Project Name: SUNSET VILLAGE

# REVIEW COMMENTS

FILE #PP-95-214

TITLE HEADING: Preliminary Plan - Sunset Village  
Subdivision

**PRELIMINARY PLAN**  
**SUNSET VILLAGE**  
**SUBDIVISION**

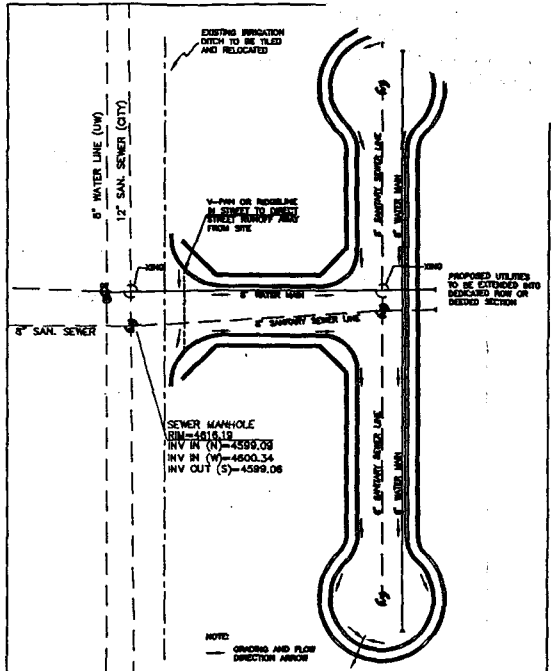
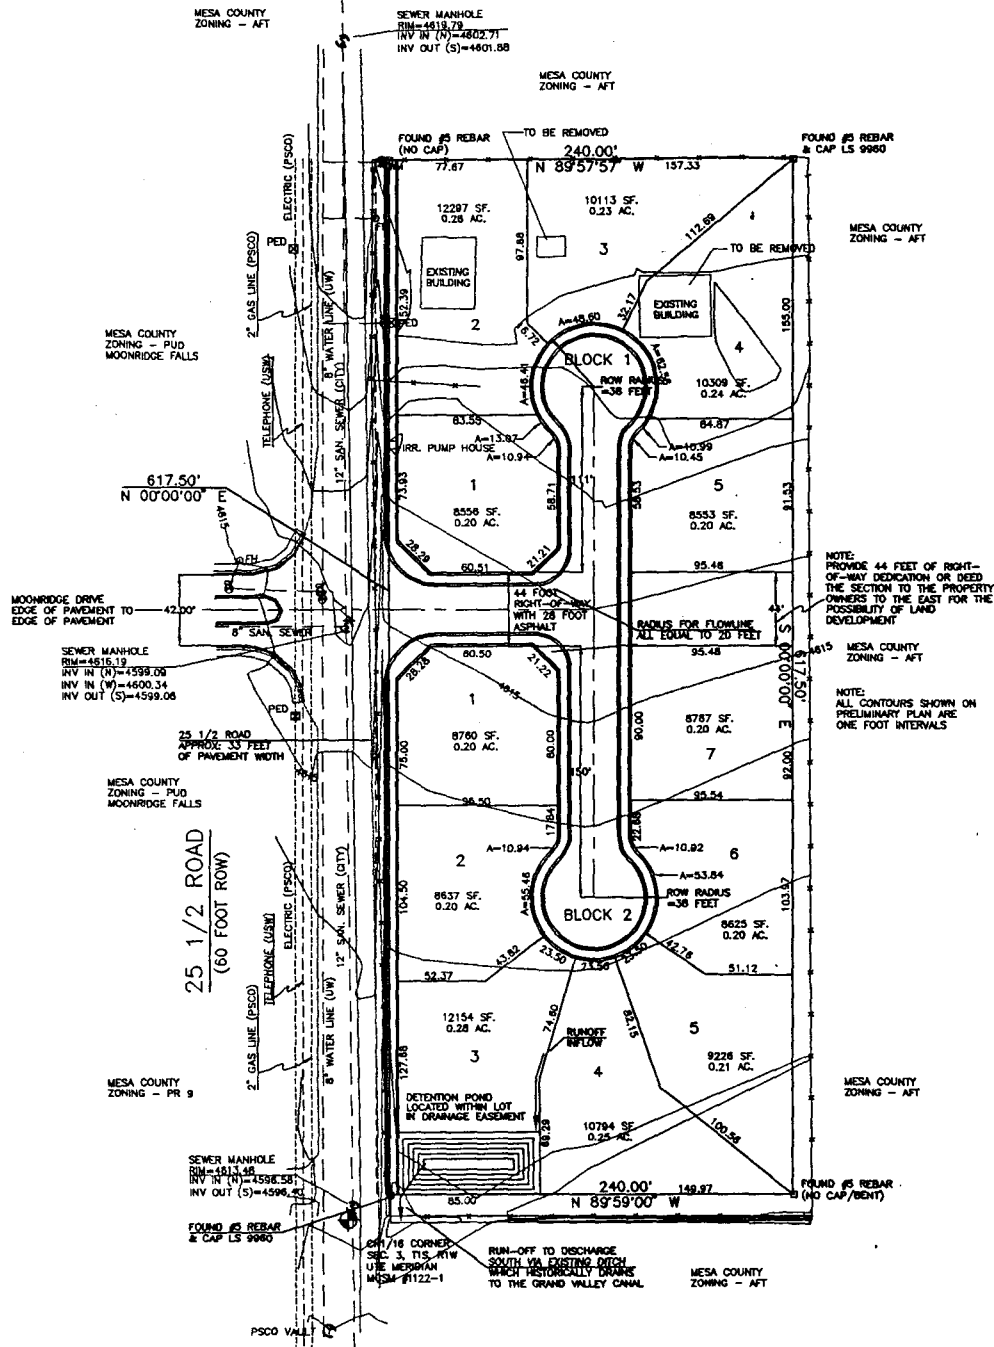
Preliminary Plan failed to present any proposed utility locations.

Preliminary plan does not comply with SSID manual.

1. No perimeter boundaries shown.
2. Is detention pond located within the lot or is it a separate tract?
3. WHERE IS PRELIMINARY PLAN? More information is needed on "concept plan." Relabel it as "preliminary plan."

- a. number lots consecutively
  - b. dimension lot and tract boundaries and street
  - c. street extension to the east is not properly shown as a street; owner/developer will be required to dedicate this area as a street and install full street improvements; the parcel to the east does not have adequate access for future development (see note below)

- d. show centerline of Moonridge Drive to the west and line up proposed street with Moonridge Drive if it is not aligned already
  - e. lot with existing building must be reconfigured to provide a 30' rear yard setback.

4. It's not necessary, nor desirable to show trees on the preliminary plan.
5. Only lot with existing building will have access to 25 1/2 Road. A note will be required to be placed on the final plat restricting access for all other lots.

6. Lot at south end of cul-de-sac has a very small building envelope.

1. Perimeter boundaries have been added to the revised preliminary plan.
2. The detention pond will be located within Lot Three, Block Two by way of a drainage easement.

3. The Concept Plan provided at the December 1 submittal date was labeled incorrectly and did not include all of the necessary information. The Preliminary Plan provided along with this letter has been modified to include all the necessary information.

- a. Lots have been numbered consecutively.
  - b. Lot dimensions and tract boundaries are provided.
  - c. The petitioner has expressed his desire to avoid building the entrance street to the property boundary. Mr. Laird would like to deed that necessary section to the property owners to the east as an alternative, or leave the decision up to the Planning Commission at the January 16th hearing.

- d. The entrance drive is now shown as being aligned exactly with Moonridge Drive to the west, this has changed the lot lines to a small degree.
  - e. Lot Two, Block One has been realigned with a 30 foot setback.

4. All landscaping has been removed from the Preliminary Plan.
5. It is the desire of the petitioner to remove the access onto 25 1/2 Road for the lot with the existing house, and provide access onto the proposed cul-de-sac.

6. The lots at the south end of the project have increased in size with the realignment of the entrance road.

9. In response to the comment from Mr. Trent Prall, utility locations have been added, without services, to the revised preliminary plan, as required in the SSID manual.

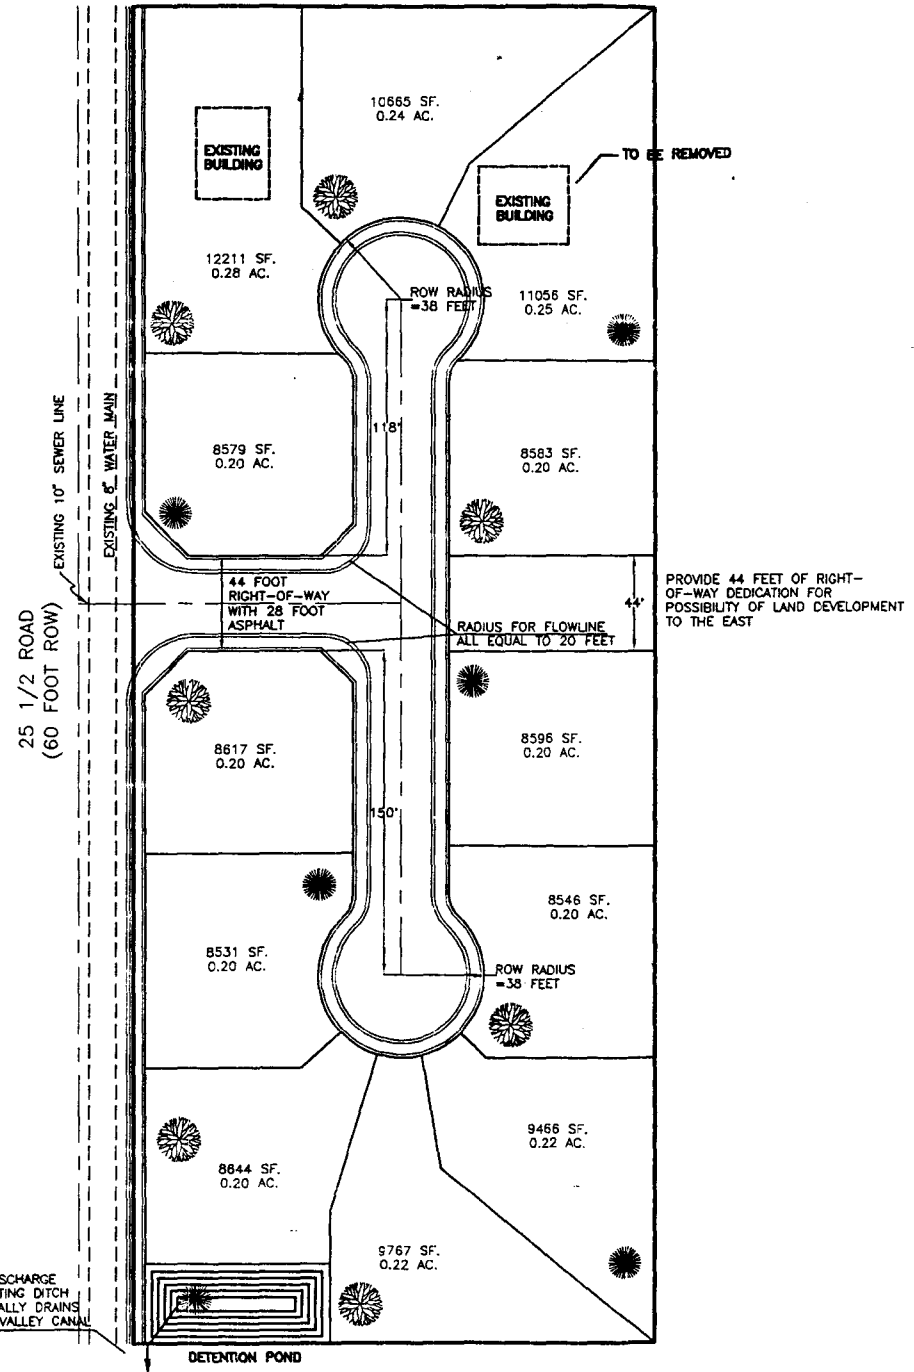
1. Submitted plan does not conform to SSID requirements for a Preliminary Plan (checklist attached).
2. Is the ownership of the ditch into which runoff will be discharged known?

1. No present of planned Grand Junction Drainage District facilities to or within the site.
2. The closest facility is a 6" tile line in the F 1/2 Road right-of-way. That 6" line cannot accept any additional flows.
3. The route and destination (i.e. Grand Valley Irrigation Company mainline???) if the surface runoff from this development needs to be shown prior to final plat approval. Some document in the permanent files of the City should show who or which agency is responsible for the "existing ditch which historically drains to the Grand Valley Canal" as shown on the concept plan.

8. In response to comment number 2, from Jody Kliska, the owner of the ditch is Mr. Richard Watson. A letter has been forwarded to Mr. Watson informing him of the preliminary drainage plan which would involve the ditch in question. A letter to Mr. Phil Bertrand of the Grand Valley Irrigation Company has been sent to his office informing him of the preliminary drainage plan as well. A copy of each letter is included with this correspondence.
